March 22, 2021

Re: 17 North Lake Rd  
Site Development Application, Site and Drainage

**DIMATTEO RESIDENCE**  
17 NORTH LAKE ROAD  
ARMONK, NY

**PLANTING PLAN**

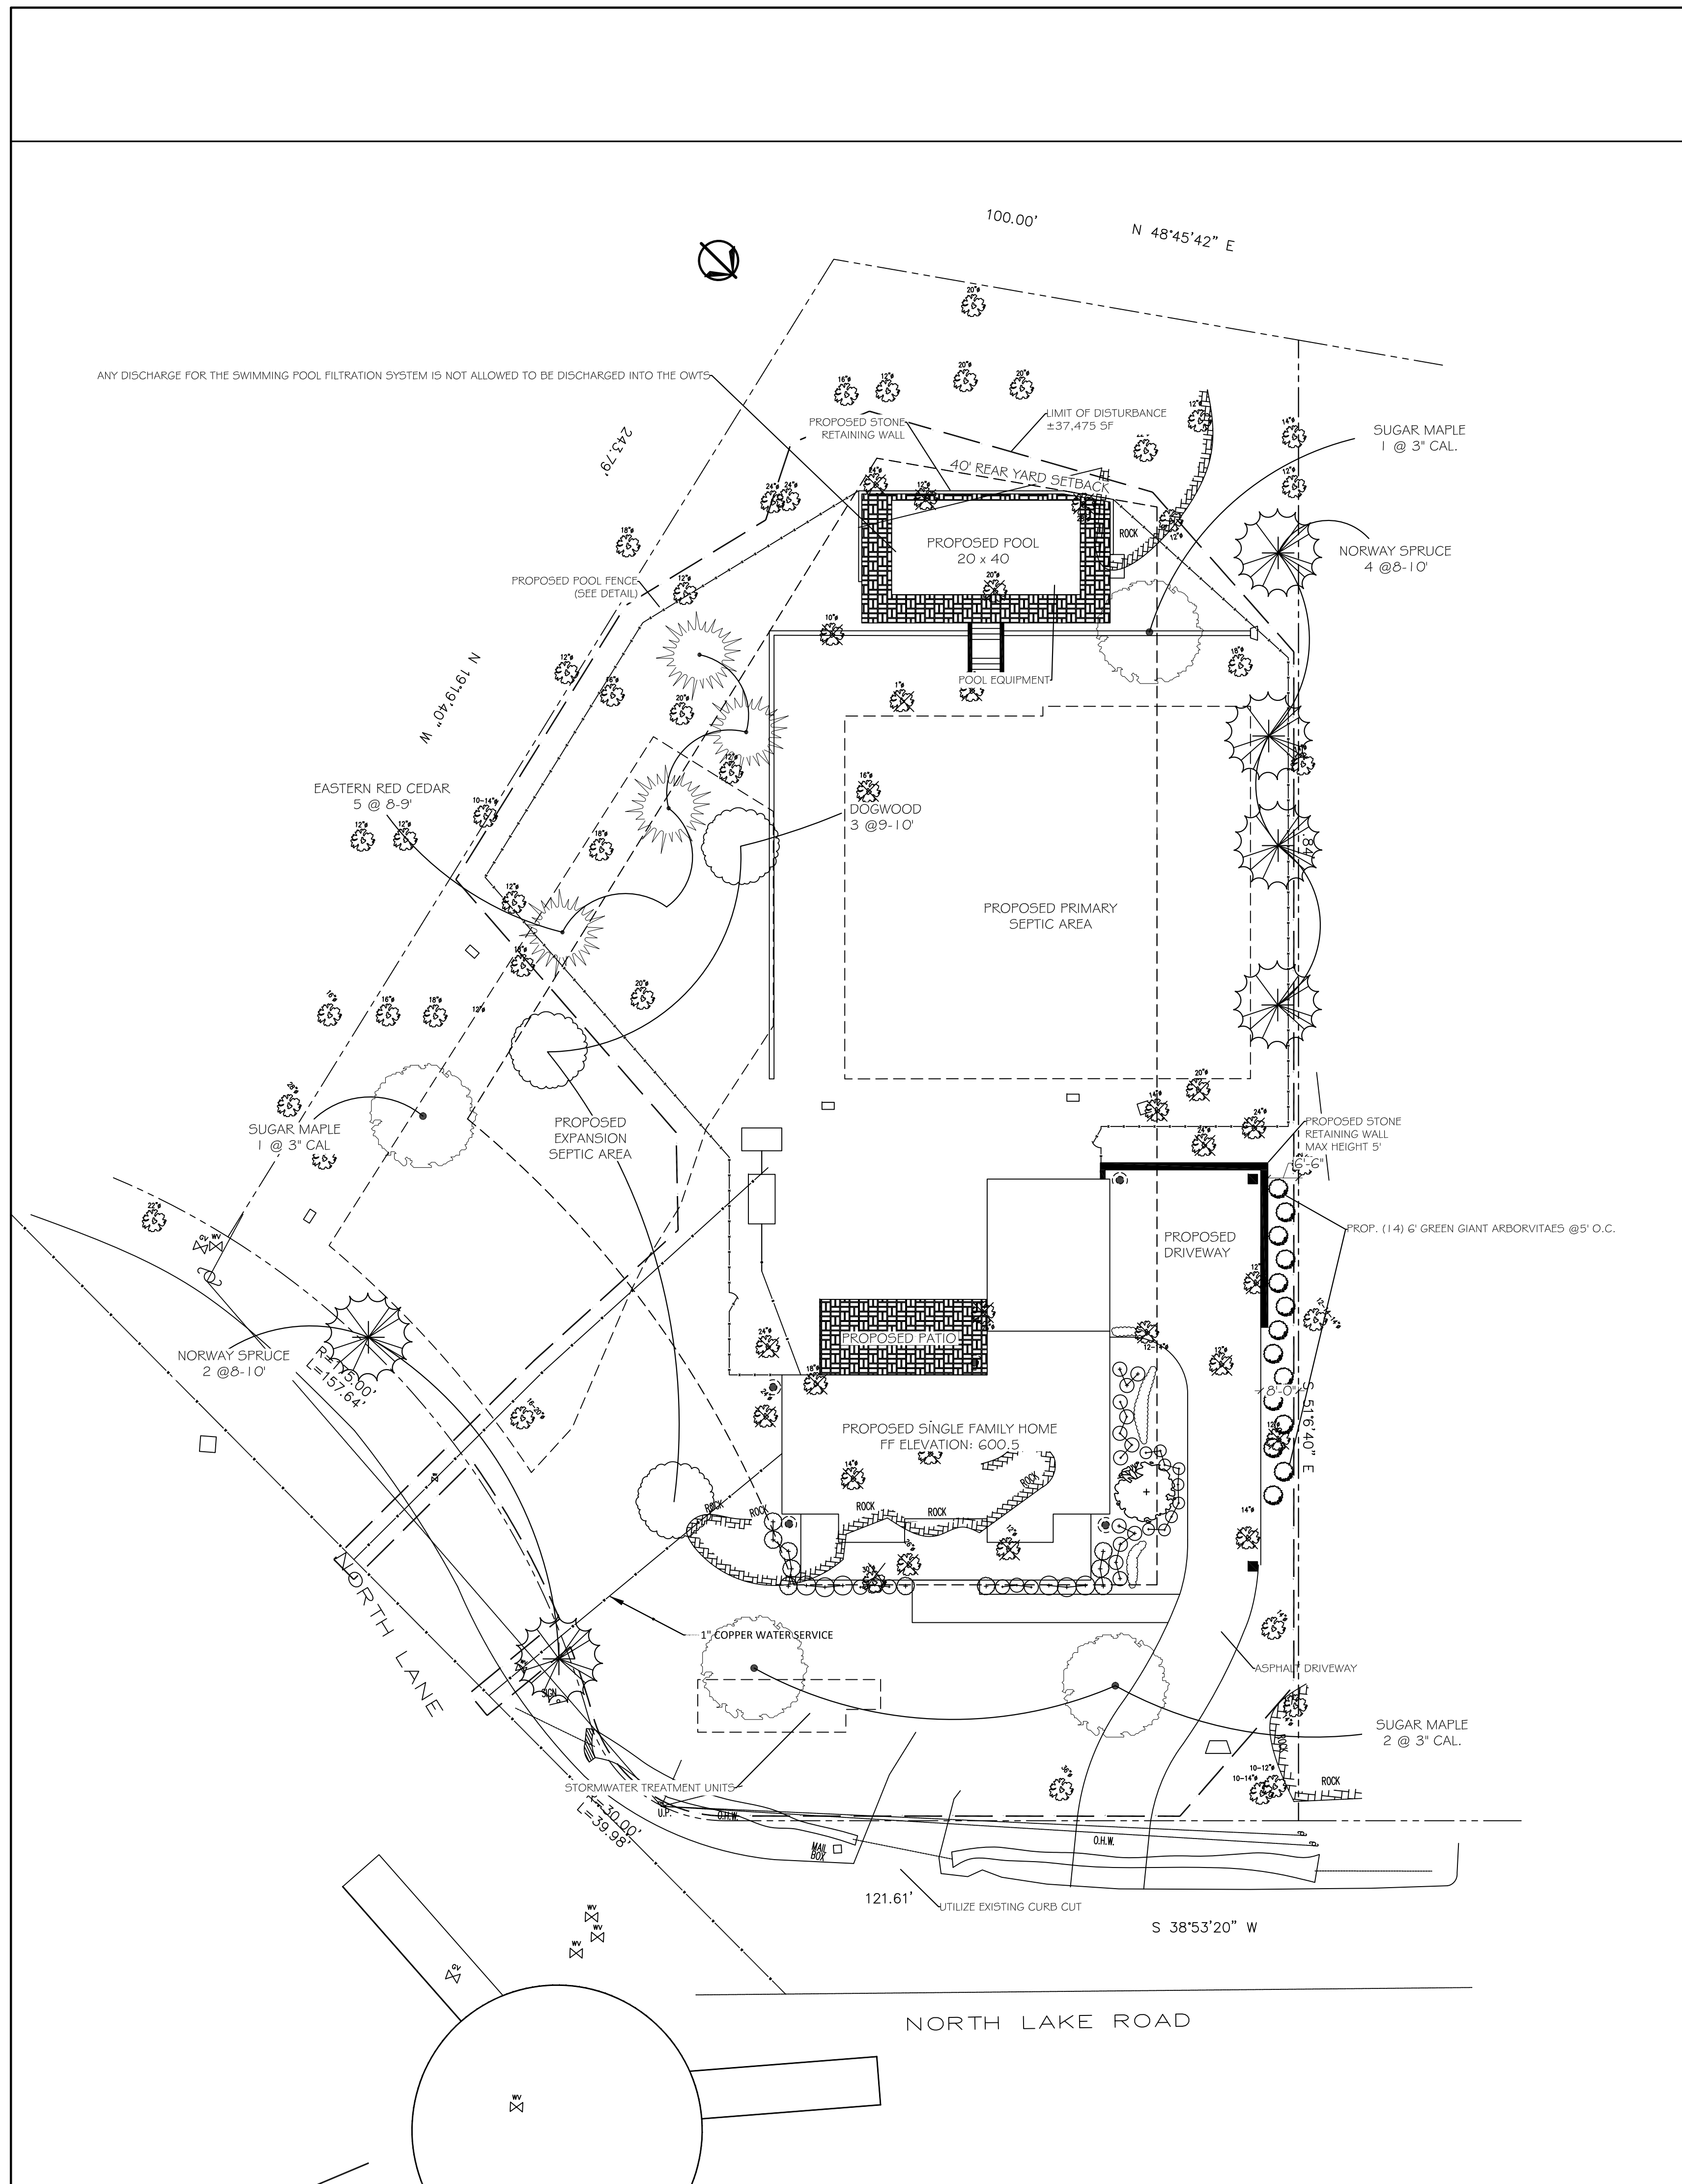
1. As previously noted, the plan proposes the removal of 25 town regulated trees, eleven (11) of which are significant, as defined by Chapter 308, Trees of the Town Code. The Planning Board shall discuss whether the proposed tree removal is appropriate for the development. The applicant should provide a Landscape Plan for consideration by the Planning Board.

*A landscaping plan is included herein.*
